ANSEMI ACRES

Improvement Plans

Anselmi Acres Subdivision
WEBER COUNTY, UTAH
Cover/Index Sheet

1400 South 5+00.00 - 9+50.00

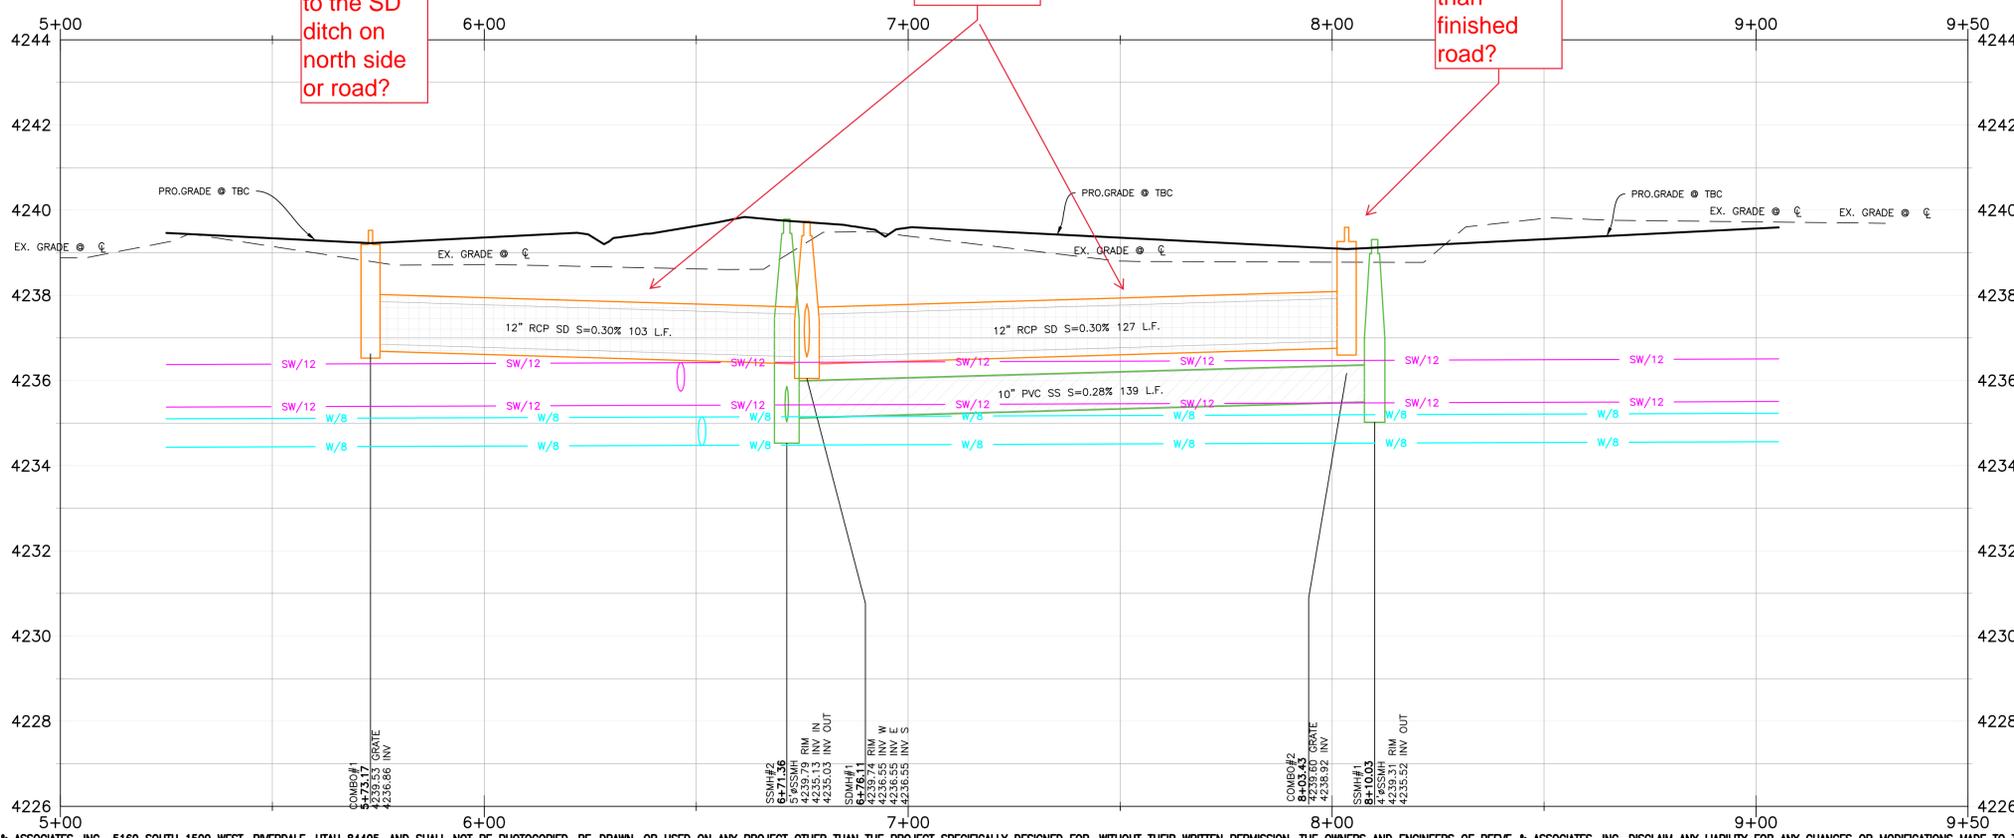
Why are they higher than finished road?

Grading Plan

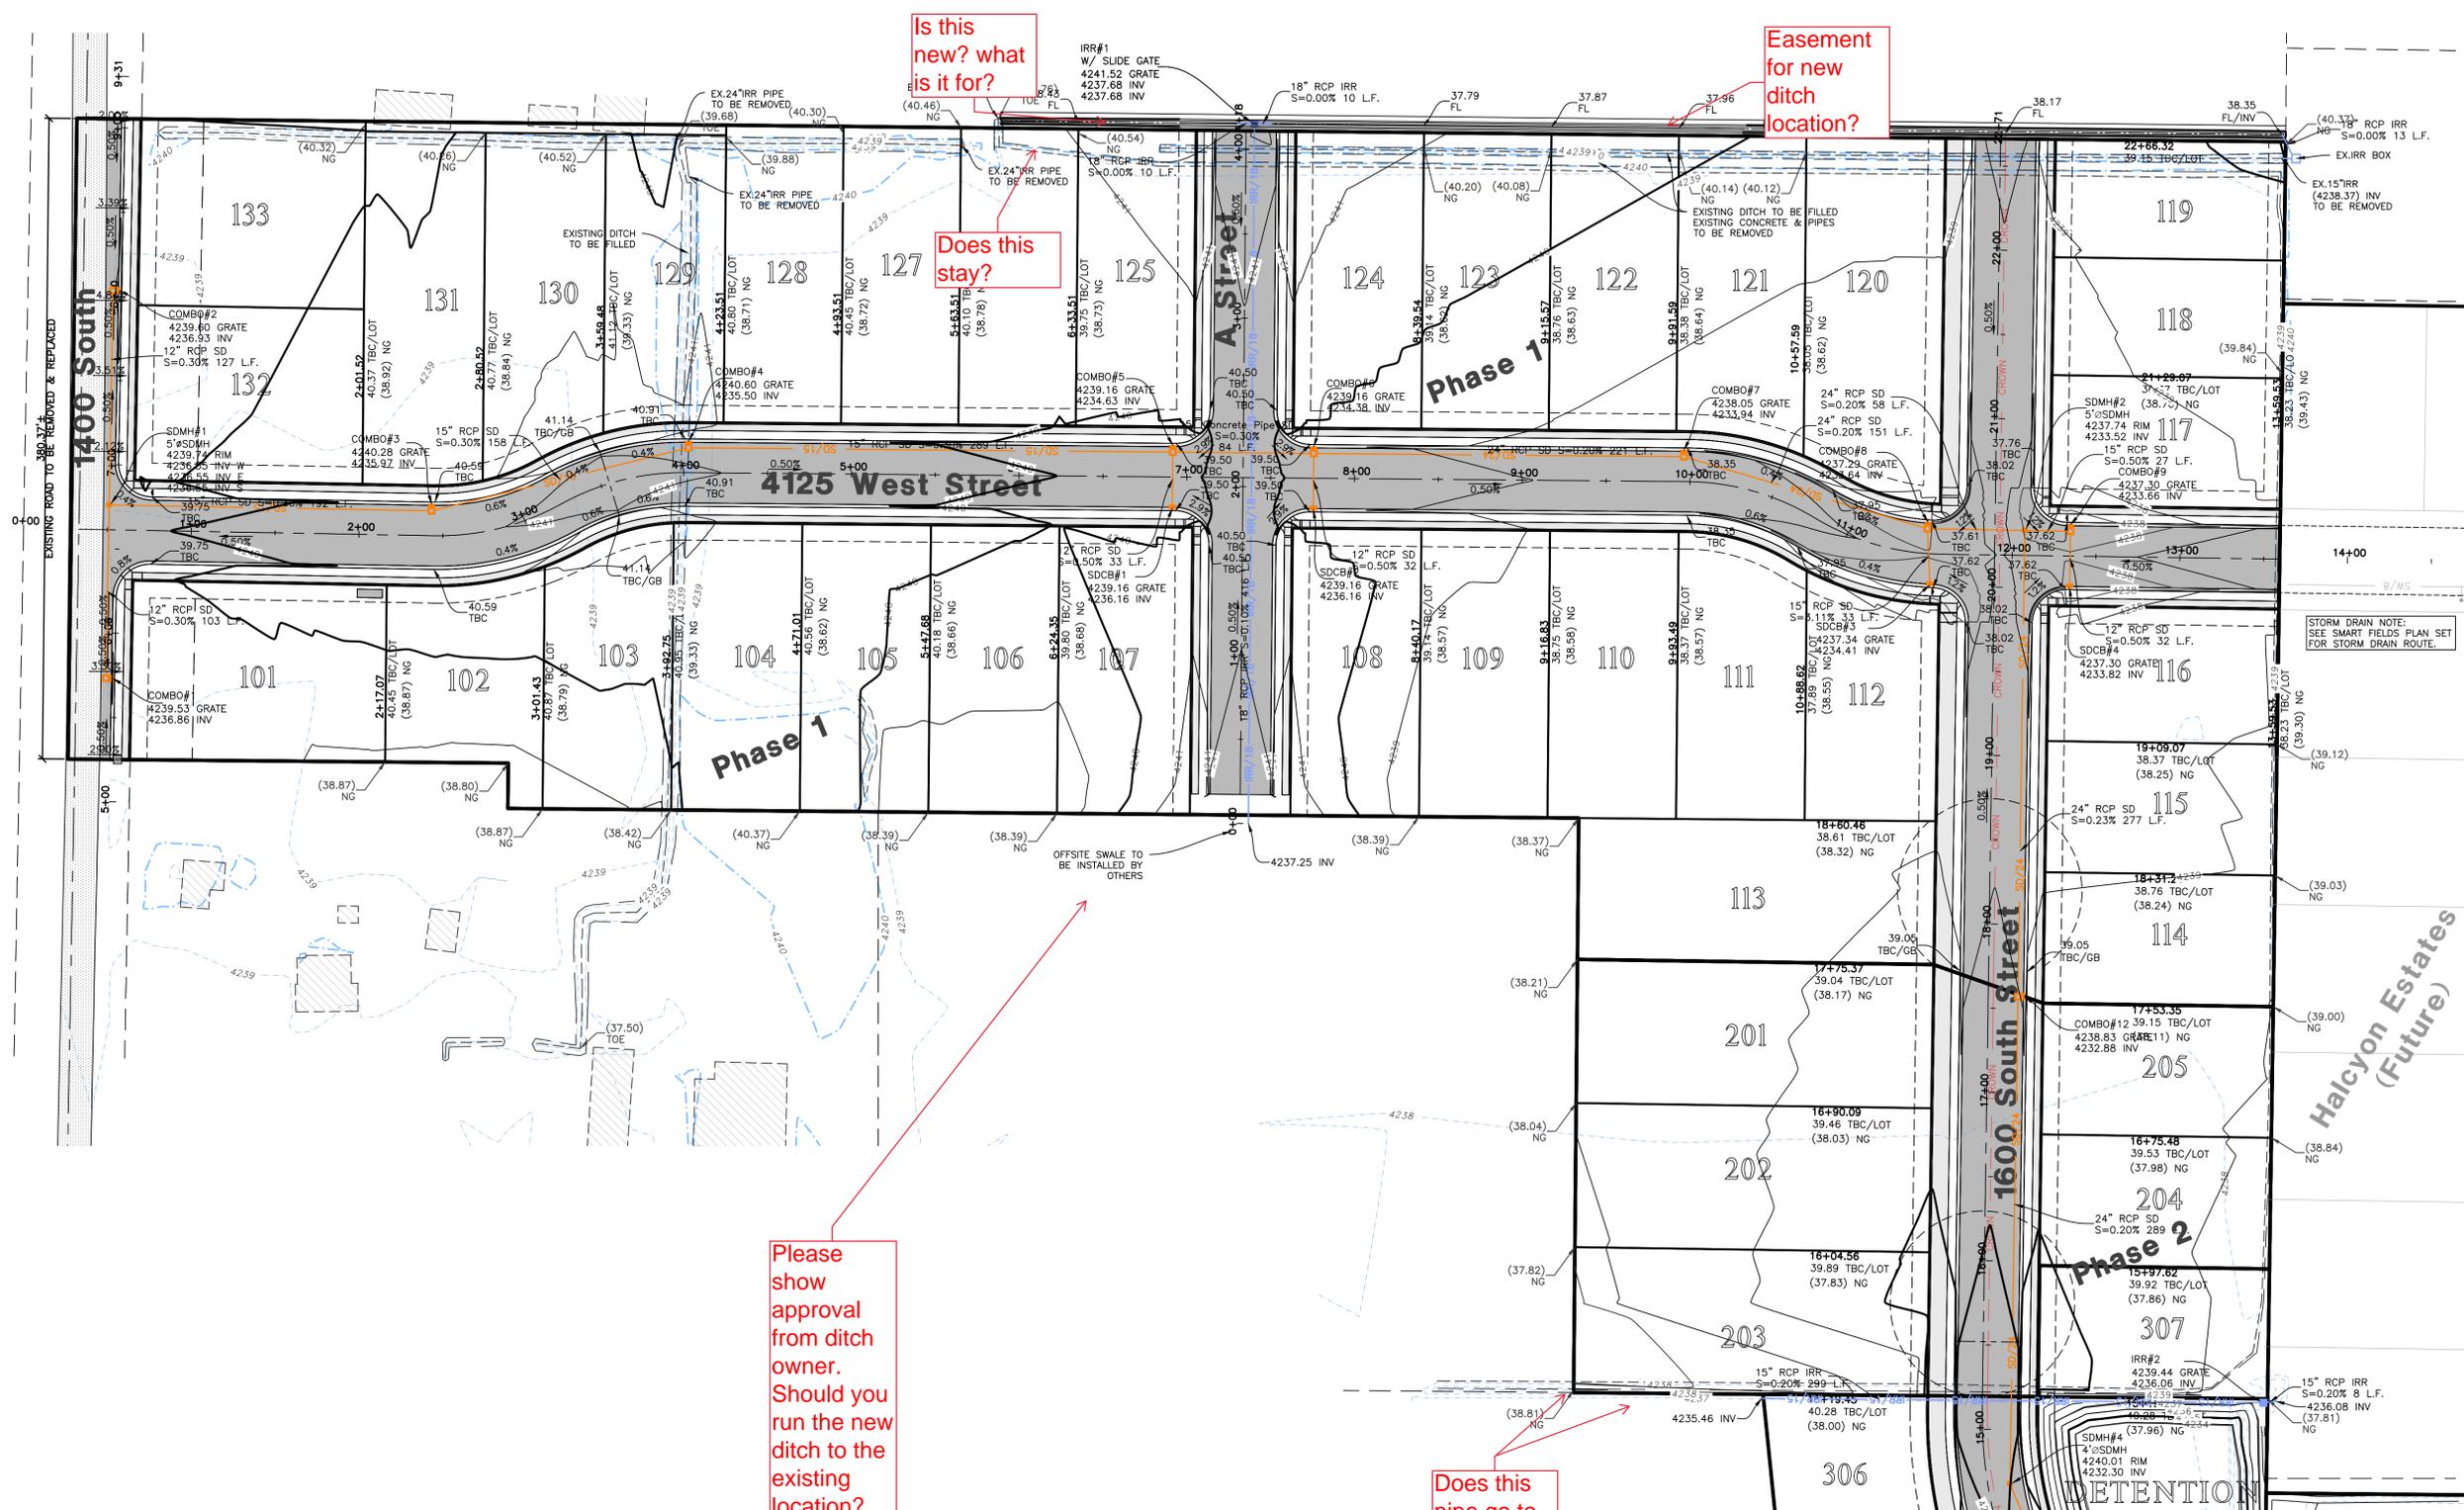
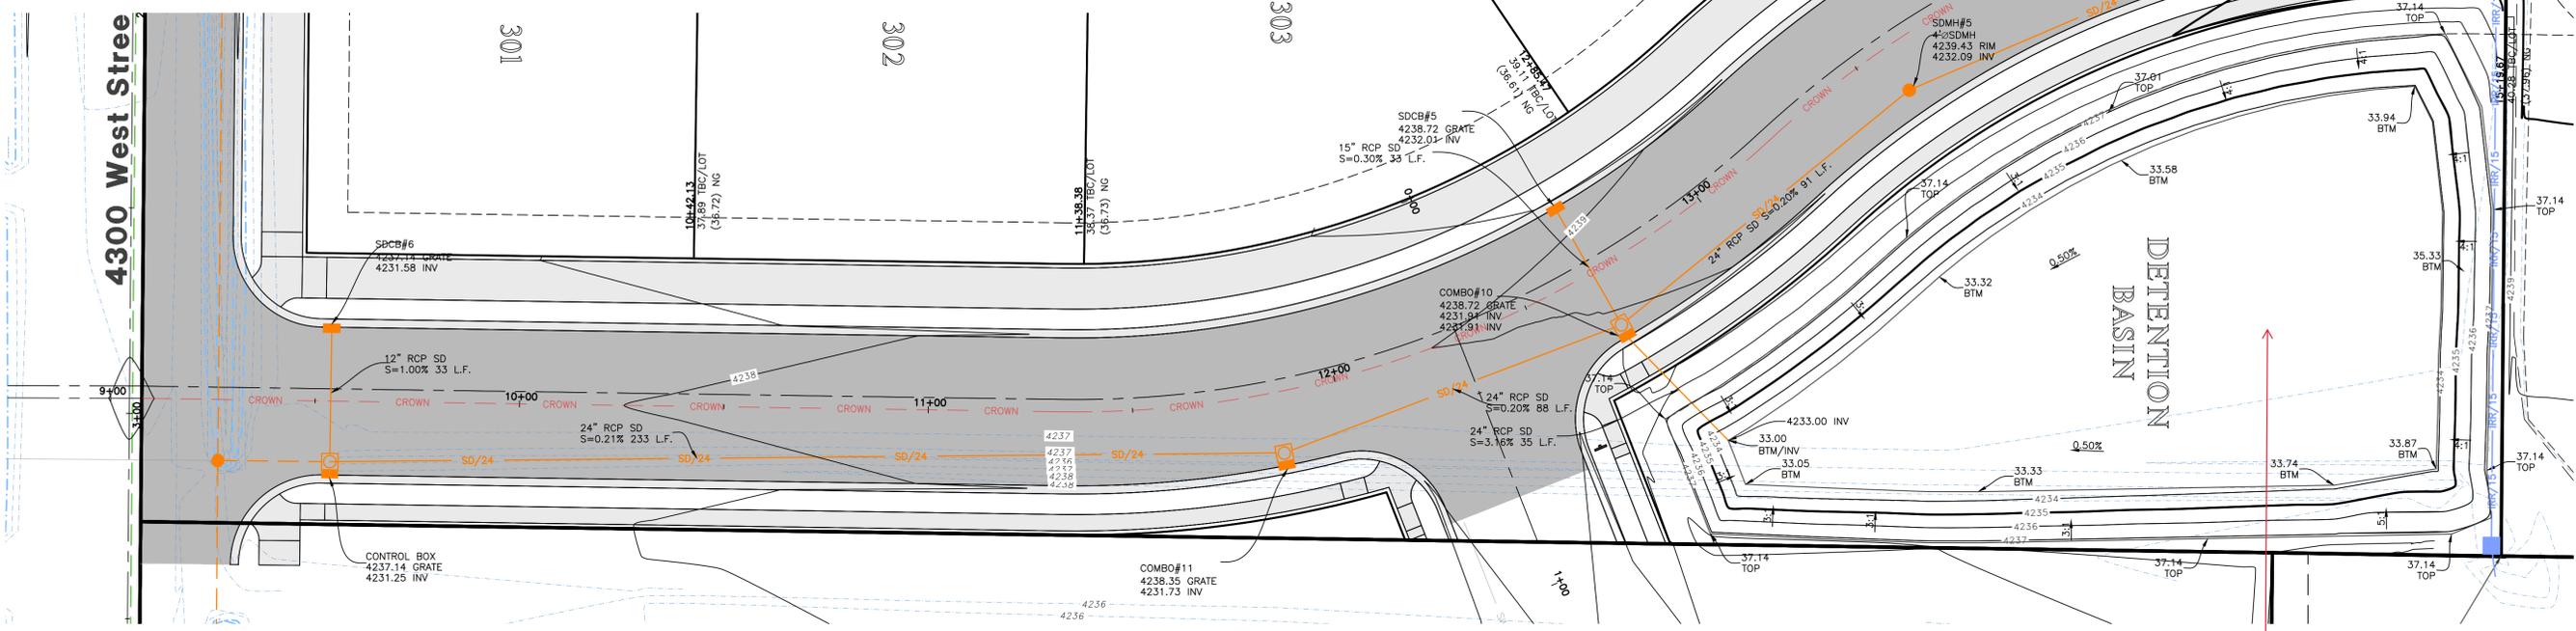
Is this new? what is it for?

Does this stay?

Easement for new ditch location?

Please show approval from ditch owner. Should you run the new ditch to the existing location?

Does this pipe go to Proper line?

Get approval for proposed ditch design and locations.
